GILMORE HALL

ADA ASSESSMENT & SURVEY

Re: ADA Accessibility Survey and Assessment – Gilmore Hall

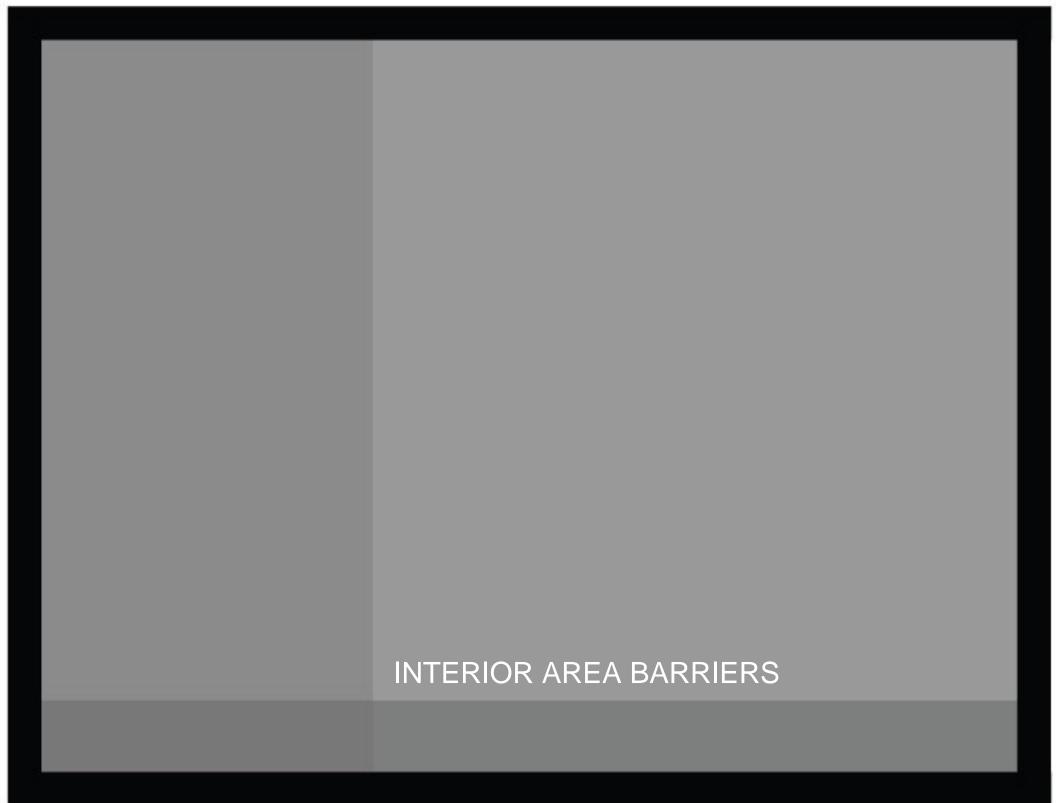
Field Date:	7/14/2011 Report Date 7/14/2011 Barrier #: 2260A
Bldg Name:	Gilmore Hall Reference Dwg: 1 of 3
Location:	Exterior - SW 26th St - Corner A
X Coordinate:	7477734.722 Y Coordinate: 340492.732
Barrier Area:	Curb Ramps
Barrier Type:	Running Slope - Existing (9.5% or more)
Code References:	OSSC 1103.2.2.1 and 2010 ADAS 406.1
Performance Sta	andard: No Quantity: EACH As-built : 1
Barrier Description:	Ramp running slope exceeds 8.3% (9.5% or more)
Findings:	14.9% running slope
Rec. Solution:	Demolish existing and construct new curb ramp
Barrier Severity:	1 Necessary Cost Est \$0.00 Facility Function: Public Status: Open
Implementation	Priority: 1 Implementation Phase: Implementation Date:
Notes: Two - w	ay intersection corners A,B
Field Date:	7/14/2011 Report Date 7/14/2011 Barrier #: 2260B
Bldg Name:	Gilmore Hall Reference Dwg: 1 of 3
Location:	Exterior - SW 26th St - Corner A
X Coordinate:	7477734.722 Y Coordinate: 340492.732

Barrier Area:	Curb Ramps
Barrier Type:	Detectable Warnings - Truncated Domes
Code References:	OSSC 1103.2.3.1 and 2010 ADAS 705.1.3
Performance Sta	andard: No Quantity: EACH As-built : 1
Barrier Description:	No truncated domes provided at curb ramp
Findings:	No detectable warnings at curb ramp
Rec. Solution:	To make accessible provide truncated domes as detectable warning
Barrier Severity:	2 Recommended Cost Est \$0.00 Facility Function: Public Status: Open
Implementation	Priority: 1 Implementation Phase: Implementation Date:
Notes: Two - w	ay intersection corners A,B
